**GENWAL MINE  
015/032**

**CHANGE TO THE RECLAMATION PLAN  
FOR THE**

**CRANDALL CANYON MINE MEMORIAL  
and the  
PORTAL WATER DISCHARGE**

**TASK # 2957**

**FIGURE 5-15**

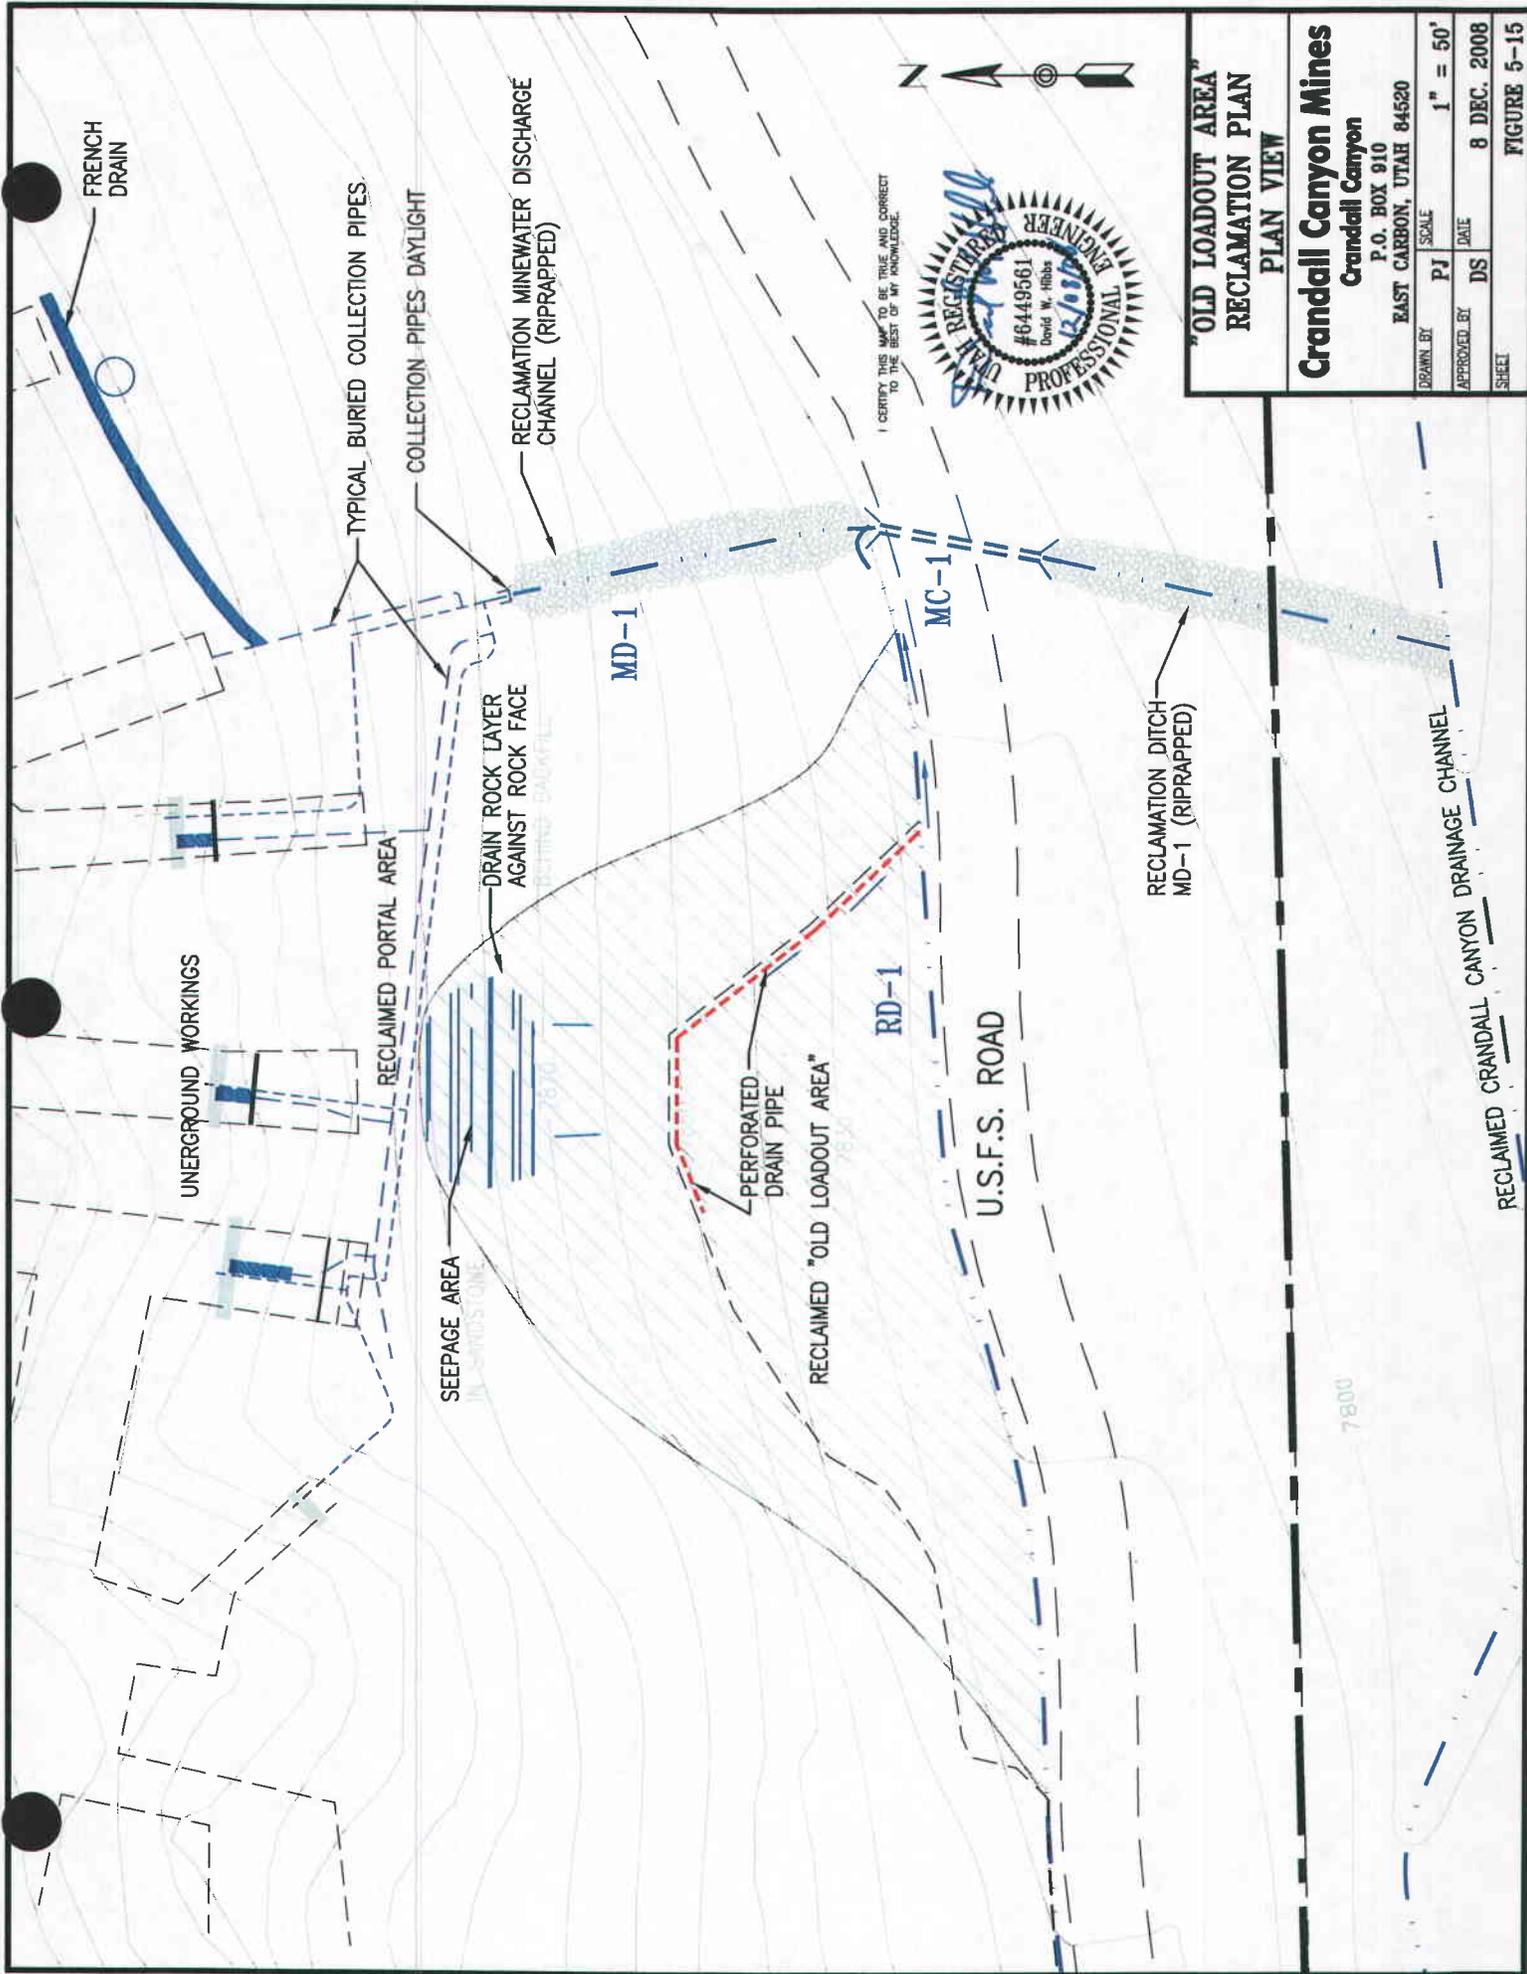
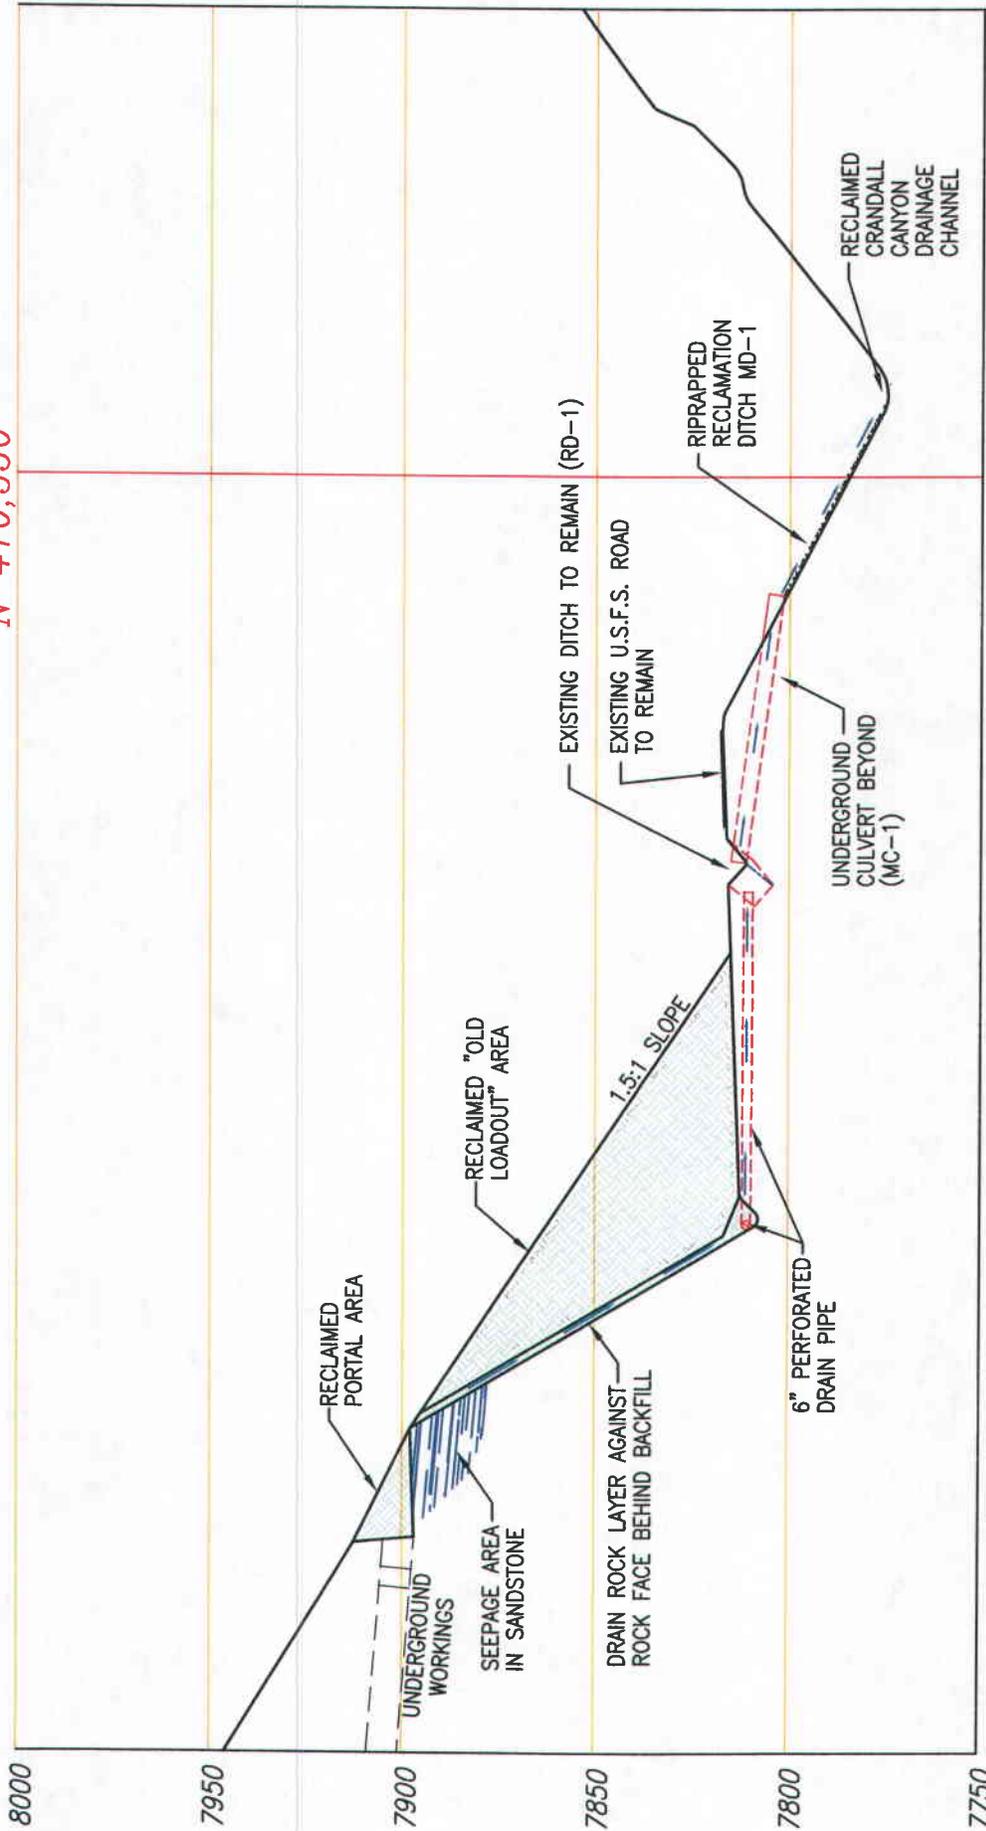
Old Loadout Area: The Old Loadout Area is located adjacent to and just north of the Forest Service road and the new loadout. This is the area where coal was previously stockpiled and loaded into trucks prior to construction of the 1997 expansion area.
